Access Compliance Report

Public Rights-of-Way

(Curb Ramps)

Intersection ID: 11911	Main Street: W_7TH_ST	Cross Street: N_CHURCH_ST	Location: W
ADA ID: 488EF4AE92AE	Ramp Type: PerpDiag	Initial Pass/Fail: Fail	Overall Compliance: No
Severity Score: 8.75			
Codes/Mitigation Info/Possible Solution		Field Measurements/Component Compliance

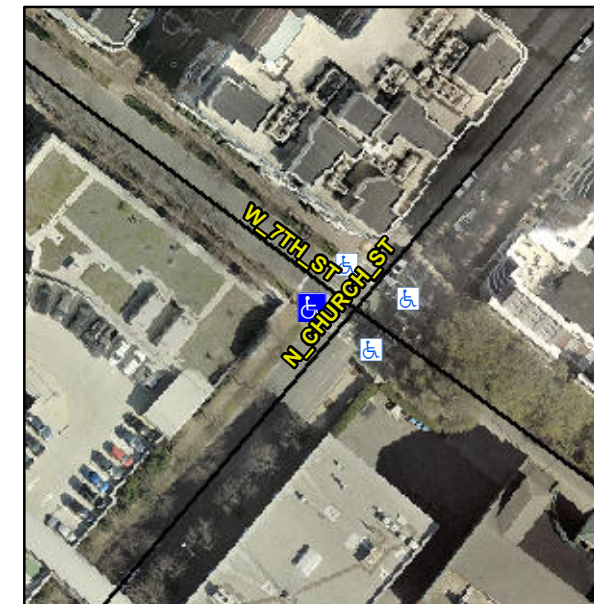
Compliance	Description	Data	Compliance	Description	Data
N/A	Ramp Length (in)	66.0	Yes	Ramp Slope (%)	5.8
No	Ramp Width (in)	41.0	Yes	Ramp XSlope (%)	1.9
N/A	Flare Type LT	N/A	N/A	Flare Type RT	N/A
N/A	Flare Slope LT (%)	N/A	N/A	Flare Slope RT (%)	N/A
N/A	Flare Traversable LT?	N/A	N/A	Flare Traversable RT?	N/A
N/A	Landing Length (in)	N/A	N/A	DWS Provided?	N/A
N/A	Landing Width (in)	N/A	N/A	DWS Contrast?	N/A
N/A	Landing Slope (%)	N/A	N/A	DWS Length (in)	N/A
N/A	Landing X Slope (%)	N/A	N/A	DWS Full Width?	N/A
N/A	Landing Curb? (Y/N)	N/A	N/A	DWS Offset (in)	N/A
N/A	Shared Landing?	N/A			
N/A	Gutter Ponding?	N/A	N/A	Gutter Slope (%)	N/A
N/A	Gutter Lip Ht (in)	N/A	N/A	Gutter X Slope (%)	N/A
N/A	Painted X Walk1?	Yes	N/A	Painted X Walk2?	Yes
	X Walk 1 Direction	To SE		X Walk 2 Direction	To NE
N/A	X Walk 1 Width (in)	83.0	N/A	X Walk 2 Width (in)	99.0
	X Walk 1 Slope (%)	6.1		X Walk 2 Slope (%)	4.7
	X Walk 1 X Slope (%)	5.0		X Walk 2 X Slope (%)	4.5

N/A	Ramp inside XWalk1?	Yes	N/A	Ramp inside XWalk2?	Yes
	Road Slope (%)	0.8	N/A	Clear Space?	N/A
	Road X Slope (%)	9.4	N/A	Clear Space to XWalk (in)	N/A
N/A	Any Obstructions?	N/A	N/A	Storm Grate/Utility Hazard?	N/A
	Obstruction Type			Storm Grate/Utility Type	
		N/A			N/A
		Yes		Surface Condition? (G/P)	Good

Remove & Replace Curb Ramp With Two New Directional Ramps or Equivalent.
